BUILDING CODE OF AUSTRALIA COMPLIANCE ASSESSMENT REPORT

PROPOSED INFILLED APARTMENT TO EXISTING RESIDENTIAL UNIT BUILDING

22 CENTRAL AVENUE MANLY NSW

REPORT NO. ► 7375.3/ Rev. 1.1

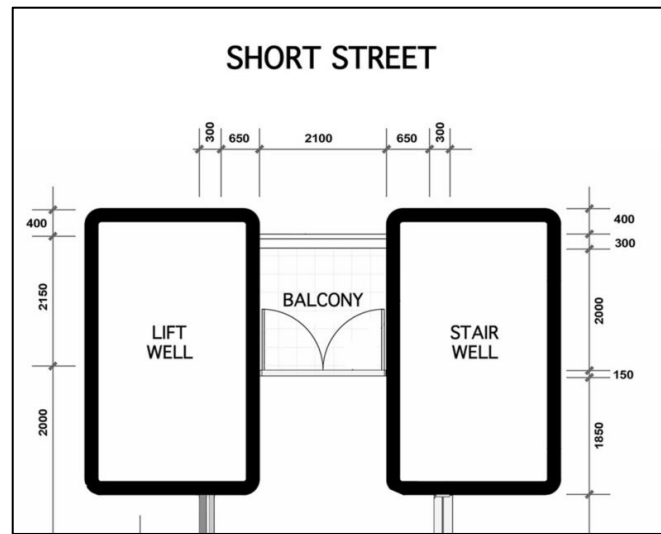
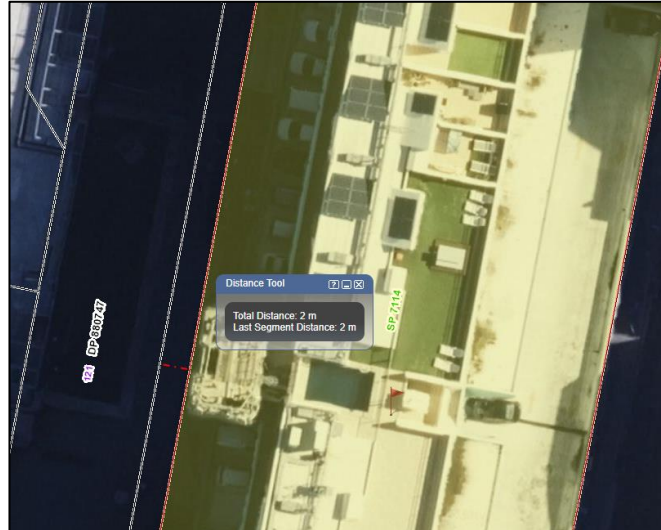
BCA Clause	Deemed-to-Satisfy Provision to be addressed
<p>C3D7 Vertical separation of openings in external walls [2019: C2.6]</p>	<p><u>Non-compliance</u></p> <p><i>The building is a Type A Construction, so vertical separation is required for openings in external walls. Where the building is sprinkler-protected throughout, vertical separation is not required.</i></p> <p><i>Despite the effective height being greater than 25m, the base building is not provided with sprinkler system throughout, in accordance with the information from the client's email to AED dated 12/09/2024.</i></p> <p><i>Based on this information, the current design does not comply.</i></p> <p><u>Central Avenue Side</u></p> <p><i>Spandrel as detailed in this BCA clause is provided in the current design separating the openings above and below. This BCA clause is not complied.</i></p> <div style="display: flex; justify-content: space-around;">   </div> <p><u>Short Street Plaza Side</u></p> <p><i>Similarly, the proposed openings on the Short Street Plaza side are not provided with vertical separation.</i></p> <p><i>Note that, as shown in Figure C3D7c of Guide to C3D7 (see below), a slab with FRL and dimensions specified by this BCA clause is considered as a horizontal spandrel when it is protruding from the external wall with the opening. The proposed lower level of each unit is not provided with such horizontal construction separating the below opening. Therefore, it is not considered as vertical separated by horizontal construction.</i></p>

This is considered as technical non-compliance.

Typical part floor plan of each SOU

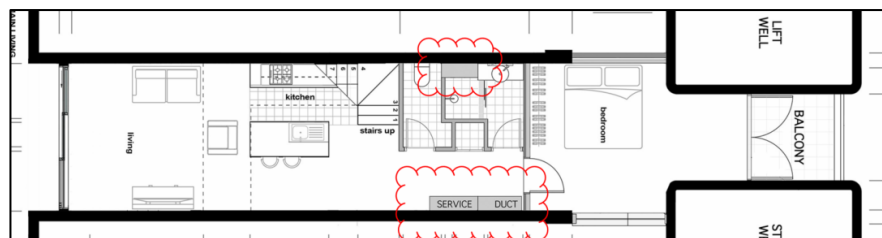
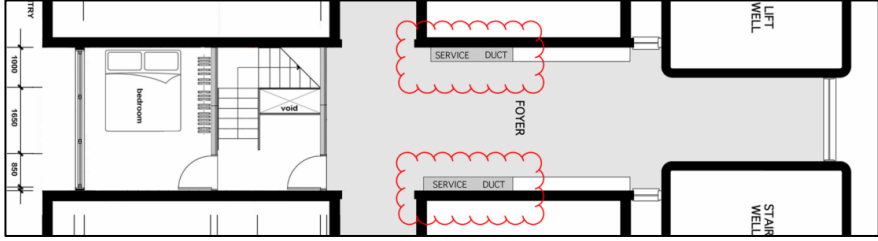
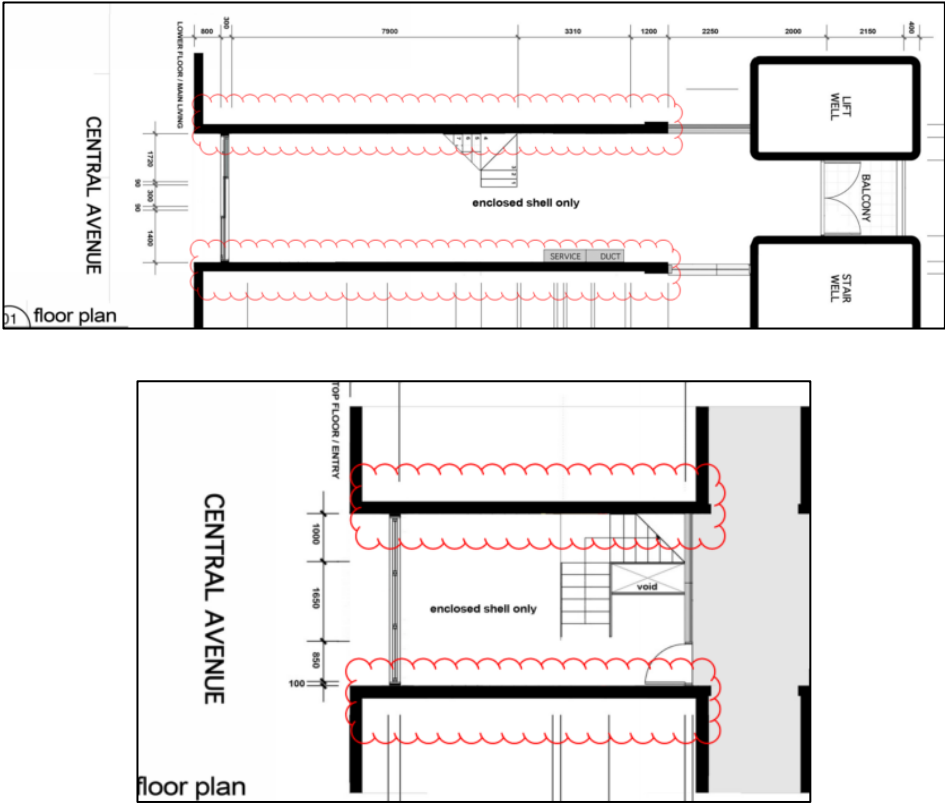
C4D3 Protection of openings in external walls [2019: C3.2]	<p>Compliance Required</p> <p><i>BCA Clause C4D3(1) requires that the openings in an external wall that is required to have an FRL must be protected in accordance with C4D5, and if wall-wetting sprinklers are used they must be located externally, and Clause C4D3(1) only apply if the distance between the opening and the fire-source feature to which it is exposed is less than 6 m from the far boundary of a road adjoining the allotment, if not located in a storey at or near ground level.</i></p> <p><i>Given that the distance between the balcony doors and the far end of Short Street Plaza is less than 6 meters, all balcony doors are required to be protected in</i></p>

compliance with BCA Clause C4D5. It is recommended that a Performance Solution be provided to negate the need for fire suppression.

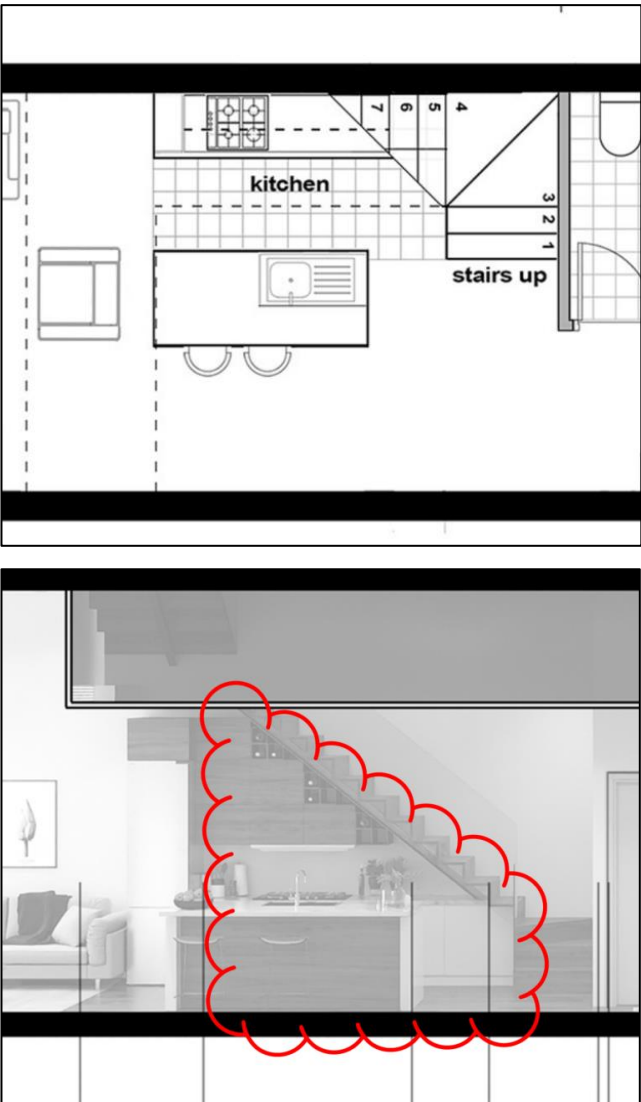
It appears that there are service penetrations throughout all proposed SOUs, as indicated in the clouded areas of the screenshot below. These penetrations must be protected by a shaft that complies with BCA Specification 5 or protected in accordance with BCA Clause C4D15.

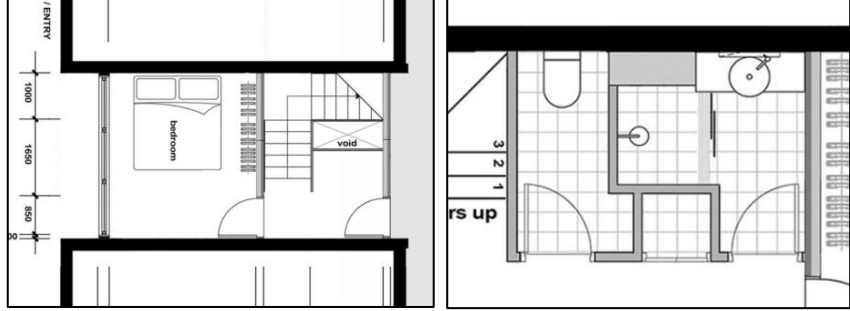
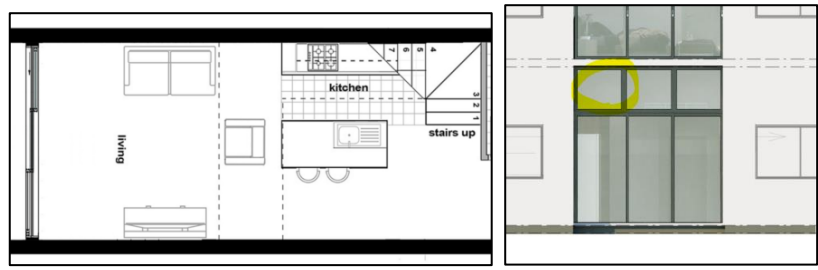
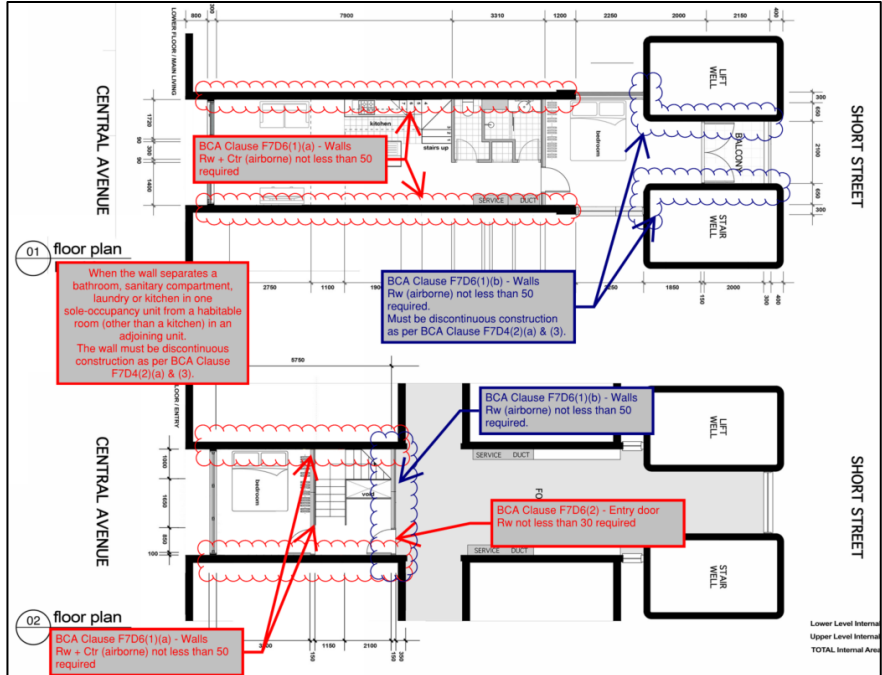
BCA Clause	Deemed-to-Satisfy Provision to be addressed
	 <p style="text-align: center;"><i>Typical markups for each SOU.</i></p>
<p>S5C11</p> <p>Type A fire-resisting construction — Fire-resistance of building elements</p> <p>[2019: Spec C1.1: 3.1 and Table 3]</p>	<p>Compliance Required</p> <p><i>The walls highlighted in the screenshot below were originally external walls and, as such, were not required to be fire-rated. However, with the proposed development, these walls will now serve as internal bounding walls between SOUs.</i></p> <p><i>To comply with the relevant standards, ensure that these walls achieve the required Fire Resistance Level (FRL):</i></p> <ul style="list-style-type: none"> • <i>Loadbearing walls: FRL of 90/90/90.</i> • <i>Non-loadbearing walls: FRL of -/60/60.</i>  <p style="text-align: center;"><i>Typical markups for each proposed SOU.</i></p>
<p>D3D20</p> <p>Barrier climbability</p> <p>[2019: Table D2.16a]</p>	<p>Compliance Required</p> <p><i>If air-conditioning condensers are proposed for each SOU, the only location for these condensers within an SOU is the balcony.</i></p> <p><i>Ensure that the condenser is positioned in such a way that it does not create any climbable elements, which could result in a potential fall from height.</i></p>

BCA Clause	Deemed-to-Satisfy Provision to be addressed
	<p style="text-align: center;"><i>Typical part floor plan of each SOU.</i></p>
E1D2 Fire hydrants [2019: E1.3]	<p><u>Compliance Required</u></p> <p><i>This building is required to be equipped with a fire hydrant system. A qualified hydraulic engineer must confirm that the system is compliant and provides compliant system coverage.</i></p>
E1D5 Where sprinklers are required: all classifications [2019: Table E1.5]	<p><u>Non-compliance</u></p> <p><i>Given that the base building has an effective height of more than 25 meters, the development must be equipped with a fire suppression system <u>throughout</u> in compliance with AS 2118.1 and BCA Specification 17.</i></p> <p><i>As per the email confirmation to AED dated 12/09/2024, the base building is not provided with sprinkler system throughout, so this BCA 2022 Clause E1D5 cannot be complied until the entire building (existing and proposed parts) is provided with a compliant sprinkler system, although the proposed development is for part of the building only.</i></p>

Markup showing the distance to Central Avenue.

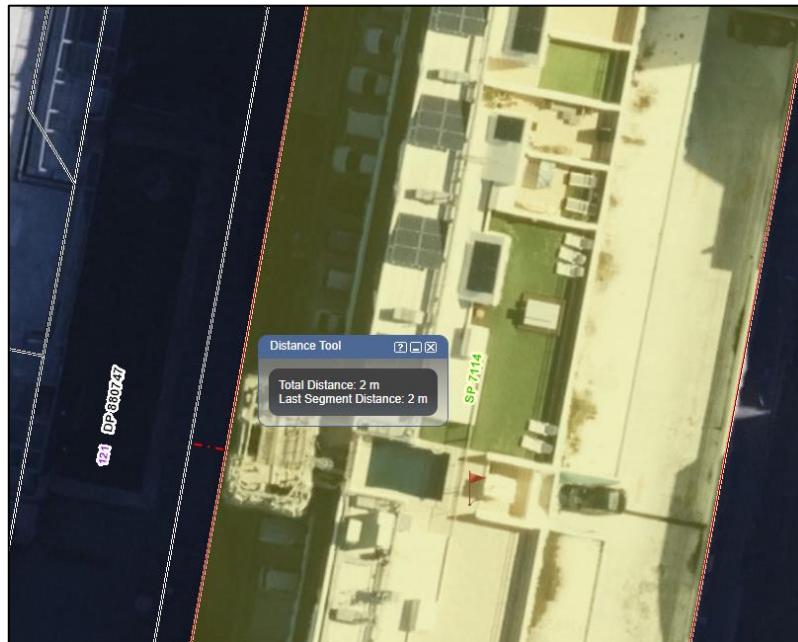
- North – adjacent SOU – N/A
- South – adjacent SOU – N/A
- East – Far end of Central Avenue - >6m
- West – Far end of Short Street Plaza – **Potentially with 6m from proposed openings.**

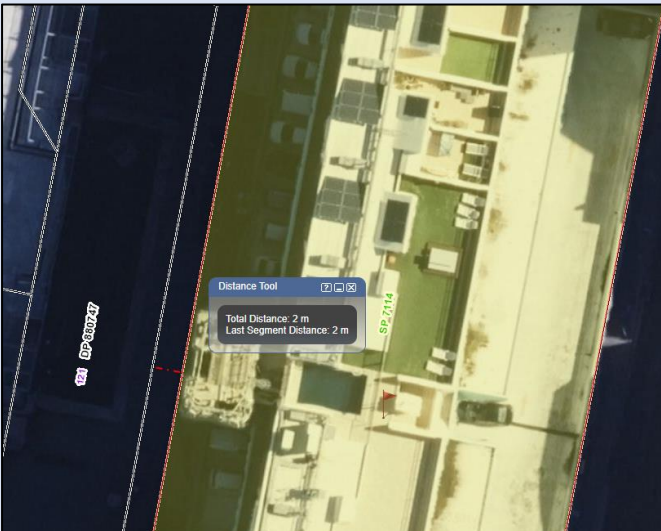
BCA DEEMED-TO-SATISFY PROVISION	COMPLIES	DOES NOT COMPLY	Informational NA or	Compliance Required	COMMENTS
C3D11 Separation of lift shafts [2019: C2.10]				X	<p>Details demonstrating compliance with this clause must be incorporated into the construction certificate plans / specification</p> <p>(1) Any lift connecting more than 2 storeys, or more than 3 storeys if the building is sprinklered, (other than lifts which are wholly within an atrium) must be separated from the remainder of the building by enclosure in a shaft in which—</p> <p>(a) in a building required to be of Type A construction — the walls have the relevant FRL prescribed by Specification 5; and</p> <p>(b) in a building required to be of Type B construction — the walls—</p> <p>(i) if loadbearing, have the relevant FRL prescribed by Tables S5C21a to S5C21f of Specification 5; or</p> <p>(ii) if non-loadbearing, be of non-combustible construction.</p> <p>(3) An emergency lift must be contained within a fire-resisting shaft having an FRL of not less than 120/120/120.</p> <p>(4) Openings for lift landing doors and services must be protected in accordance with the Deemed-to-Satisfy Provisions of Part C4.</p> <p>Details demonstrating compliance with this clause must be incorporated into the construction certificate plans / specification</p> <p>Compliance Required</p> <p>The existing lift shaft must not be compromised by the proposed development and must achieve a FRL of not less than 120/120/120.</p>

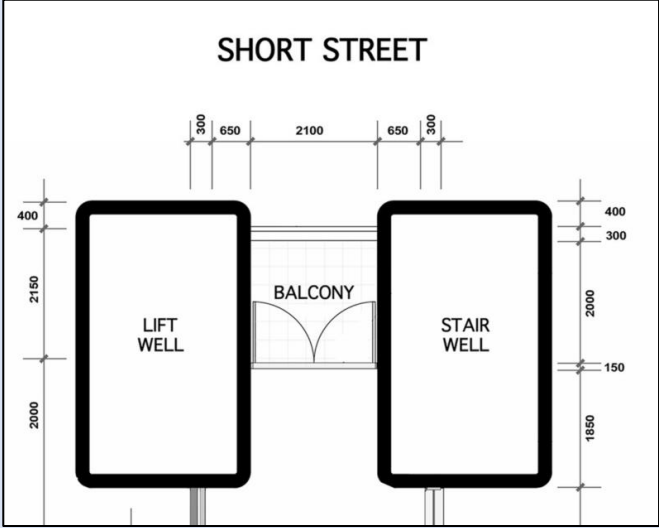
C3D15 Public corridors in Class 2 and 3 buildings [2019: C2.14]		X			<p>In a Class 2 or 3 building, a public corridor, if more than 40 m in length, must be divided at intervals of not more than 40 m with smoke-proof walls complying with S11C2.</p> <p><i>Details demonstrating compliance with this clause must be incorporated into the construction certificate plans / specification</i></p> <p><i>Potential Non-compliance</i></p> <p><i>Based on the Site Plan, the public corridors are approximately 81 meters in total length and do not appear to be provided with any smoke separation.</i></p> <p><i>It is likely that this DtS non-compliance existed in the building prior to the current development. Therefore, it is expected that this issue has already been addressed by a Performance Solution. If an existing Fire Engineering Report has previously addressed this DtS non-compliance (formerly BCA Clause C2.14), a re-assessment by a qualified fire engineer may be required for this proposal.</i></p> <p><i>Please note: The drawing is not to scale, so the measurement is approximate.</i></p>

BCA DEEMED-TO-SATISFY PROVISION	COMPLIES	DOES NOT COMPLY	Informational NA or	Compliance Required	COMMENTS
					<p>02 SITE PLAN - UPPER LEVEL NTS</p>
<p>Typical upper levels of proposed SOUs.</p>

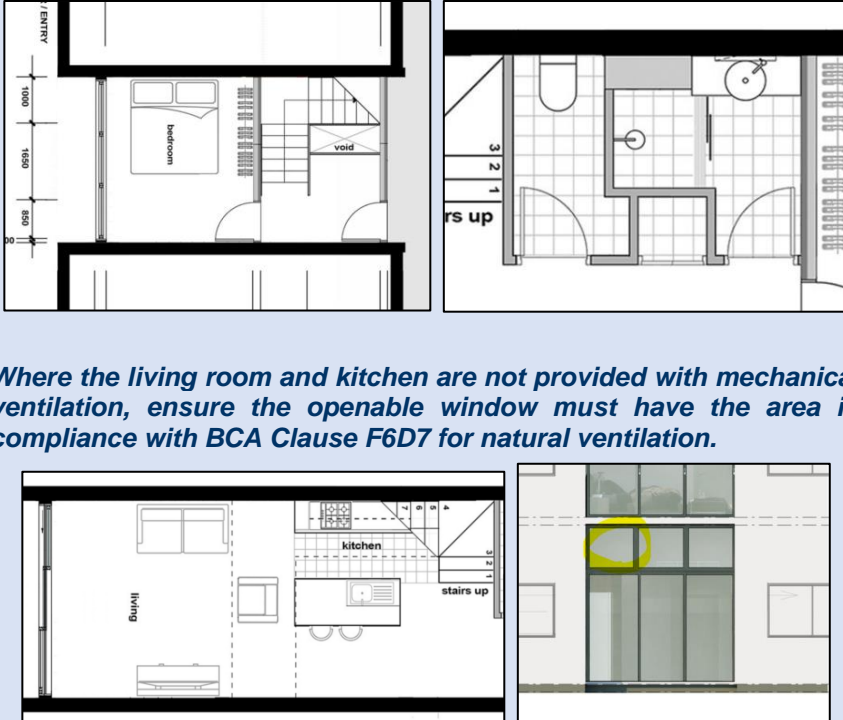
BCA DEEMED-TO-SATISFY PROVISION	COMPLIES	DOES NOT COMPLY	Informational NA or	Compliance Required	COMMENTS
					<p>height of not less than 2.1 m for not less than two-thirds of the floor area of the room or space.</p> <p>(2) For the purposes of (1), when calculating the floor area of a room or space, any part that has a ceiling height of less than 1.5 m is not included.</p> <p>(8) The height of rooms and other spaces in any building must be not less than—</p> <p>(a) for a bathroom, shower room, sanitary compartment, other than an accessible adult change facility, airlock, tea preparation room, pantry, store room, garage, car parking area, or the like — 2.1 m; and</p> <p>(b) for a commercial kitchen — 2.4 m; and</p> <p>(c) above a stairway, ramp, landing or the like — 2 m measured vertically above the nosing line of stairway treads or the floor surface of the ramp, landing or the like; and</p> <p>(d) for a required accessible adult change facility — 2.4 m.</p> <p><i>Details demonstrating compliance with this clause must be incorporated into the construction certificate plans / specification</i></p> <p><u>Compliance Required</u></p> <p><i>The current design includes sections of the units with internal fitout. However, it does not appear to account for the ceiling space, including the services within.</i></p> <p><i>It is essential to ensure that compliant head height is provided throughout the units, taking into consideration the ceiling space and any services.</i></p> <p><u>Potential Non-compliance</u></p> <p><i>For the Class 2 part of the building, the minimum head height must be no less than 2100mm in kitchen.</i></p> <p><i>To comply with BCA Clause D3D14, the maximum height of a riser is 190mm. In the SOU with an internal layout, the kitchen area is directly below a private stairway, resulting in a ceiling height that is less than the required 2100mm.</i></p>
